North Elevation

3 **Rainwater goods and disposal:**

4 Exterior walls Stone Repairs:

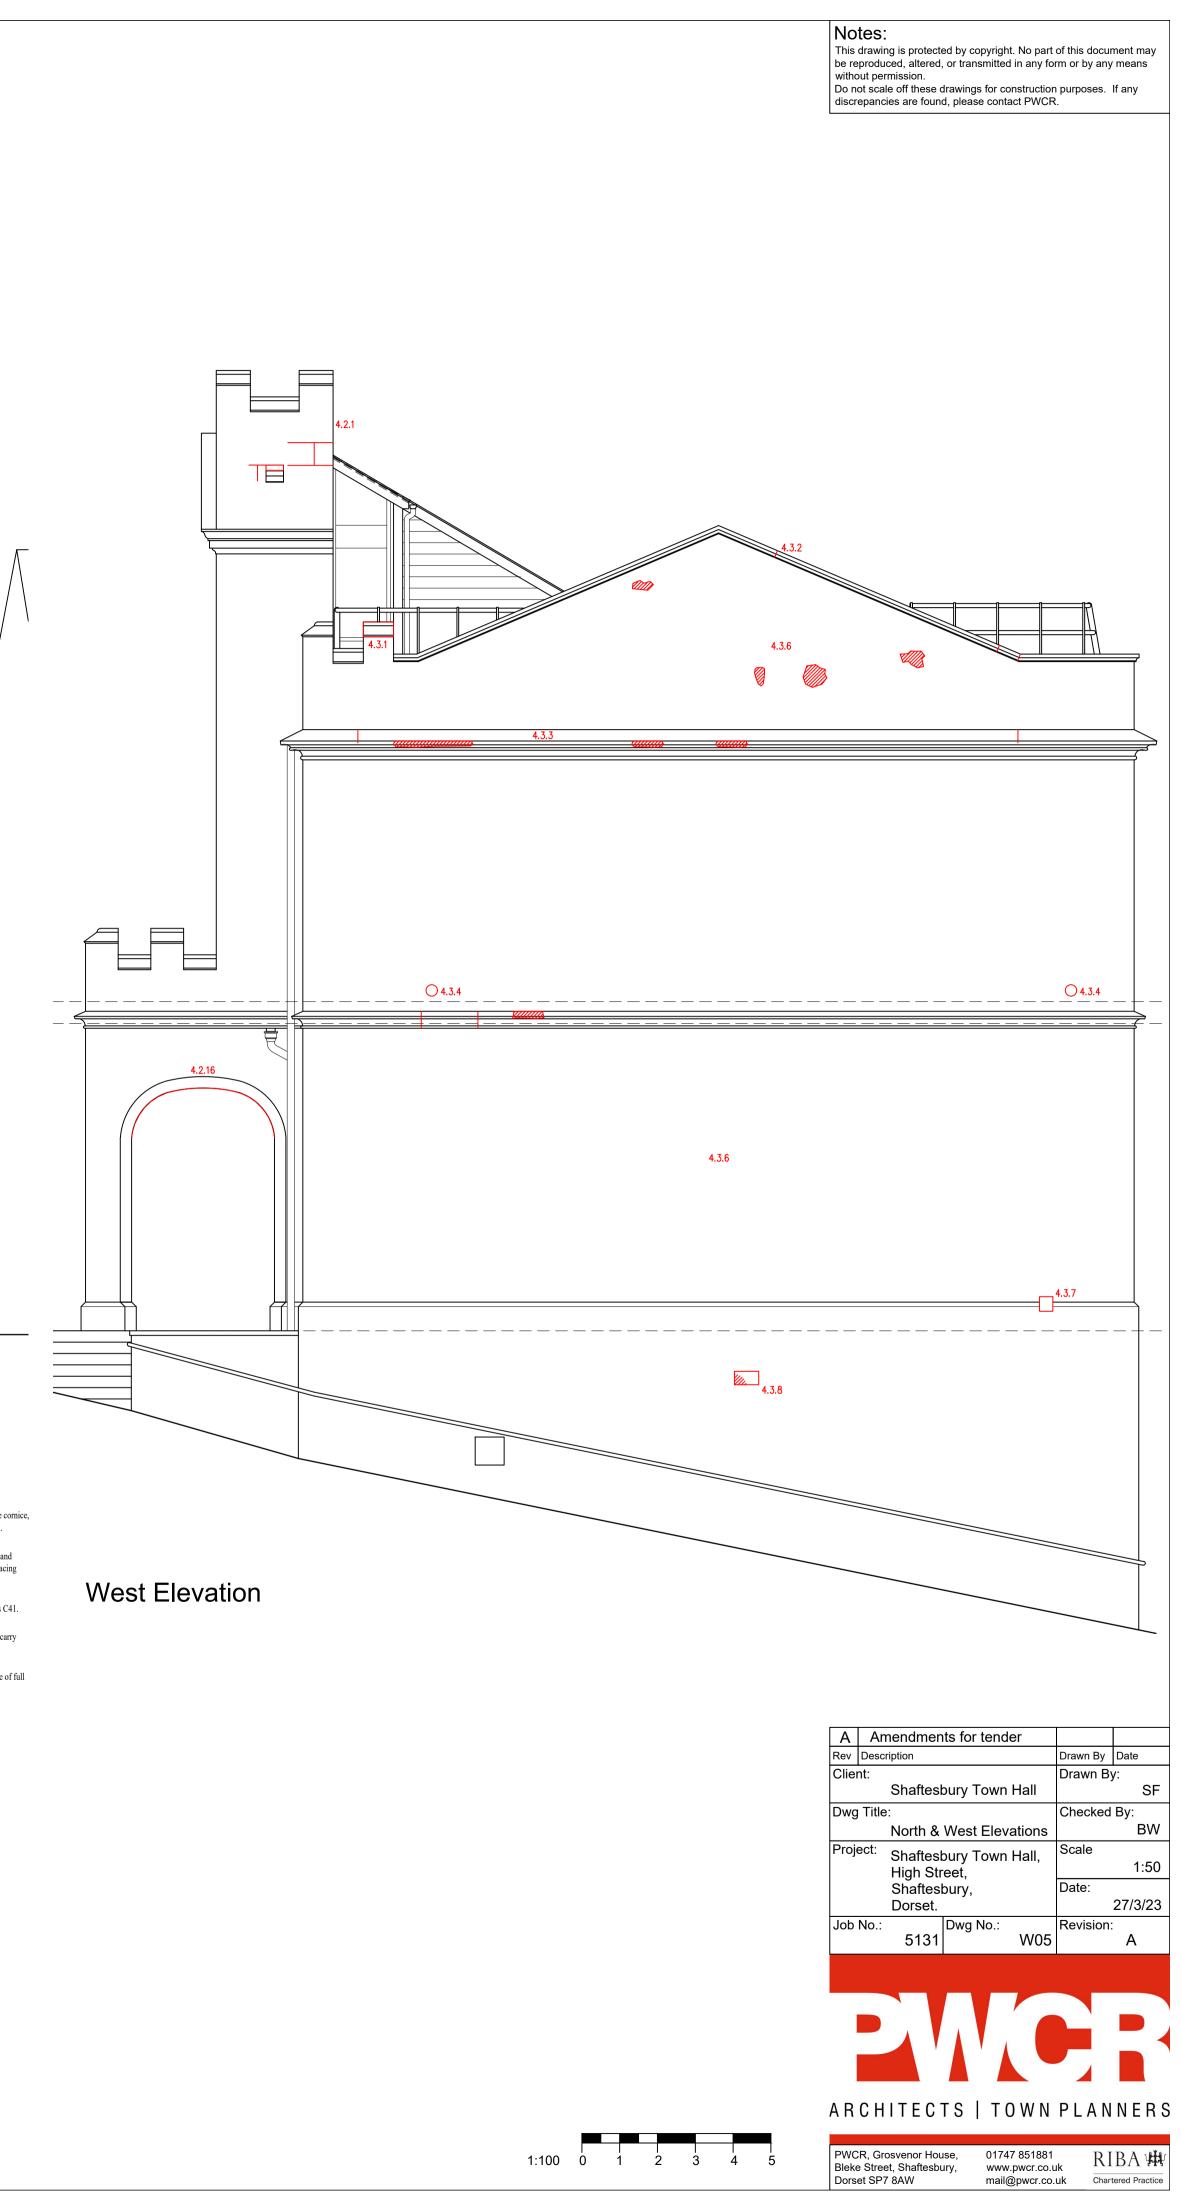
3.1 Remove existing plastic rwdp and fittings from the NE corner of the building. Re-configure the chute through the North parapet and line with lead, including overflow detail to match those of the south elevation. Fit new hopper and round cast iron downpipe to match existing passing through the cornice and string courses as described below, and attach to the existing section of cast iron pipe below (ie straight drop mounted on the North elevation). See specification section R10.

4.1 General item: In the course of stone repairs, all weathered surfaces (top of plinth, string course, window sills and cornice) are to be cleared of moss growth and vegetation with gentle scraper and stiff brush, and cleaned down with warm water. The objective is to remove moss and loam from the surface, not to 'clean' the stone. Allow to prepare a short section for approval prior to commencement - see C41.

- 4.2.1 Repoint open joints to the west side of the clock tower as marked on PWCR stone repair drawings and detailed in section C41 of this specification, and replace the missing slate louvre from the vent.

- 4.2.2 Allow to gently brush of minor scaling to the pediment of the clock tower to remove loose material.
- 4.2.3 Pin and epoxy fix sheered section of stone to (inside face) of merlon and mortar repair as section C41.

- 4.2.4 Carefully re-align the parapet stone to the East of the clock tower (where the flagpole was previously fitted) and re-pointed in its new position.

- 4.2.5 Remove moss and vegetation as described in 4.1 above, and gently brush off exfoliation and scaling to the underside moulding of the cornice. Point open joints to the cornice, (allow to fully repoint 10 no joints to this elevation).

- 4.2.6 Remove moss to the hood mould over W1.1 and gently brush off exfoliation and scaling to the underside of the moulding. Using hand tools, rake out defective mortar from the East jamb of the window and over the window head. Repair the lost face of stone using mortar repairs (Chilmark stone colour match to be agreed). Repair the stone moulding beneath the hood and two number damaged voussoirs at the RH end of the window using mortar repair as C41. Re-align where possible, pin and point open joints to the flat arched head. Note blistering beneath the hood moulding on the LHS of the window is to be carefully removed, and revealed stone re-faced.

- 4.2.7 Remove mosts to the hood mould over W1.2 and gently brush off exfoliation and scaling to the underside of the moulding. Repair the fine stone moulding beneath the hood and one number damaged voussoir using mortar repair as C41. Re-align where possible, pin and point open joints to the flat arched head. Make good damage to weathered window sill. Remove the redundant heater flue beneath the window, and block the opening using Chilmark stone facing to match existing.

- 4.2.8 Gently brush off window surround and hood mould to remove exfoliation. Using hand tools remove defective mortar repairs from arched head. Piece in missing detail from hood mould and repair two damaged voussoirs using mortar repair as C41.

4.2.19Across the North elevation allow to remove 2 no partnership security boxes, redundant metal angles (for window boxes) and fixings, 5 no redundant ironwork fittings, town council notice boards and make good fixings. Also allow to remove redundant plug holes in stone facing and repair with mortar (20 total)
town council notice boards and make good fixings. Also allow to remove redundant plug holes in stone facing and repair with mortar (20 total)

4.2.20Form a chute through the parapet, and holes through string course and cornice to accommodate the re-positioned downpipe to the East end of the north elevation as shown on drawings and to match the downpipe to the west of the porch.
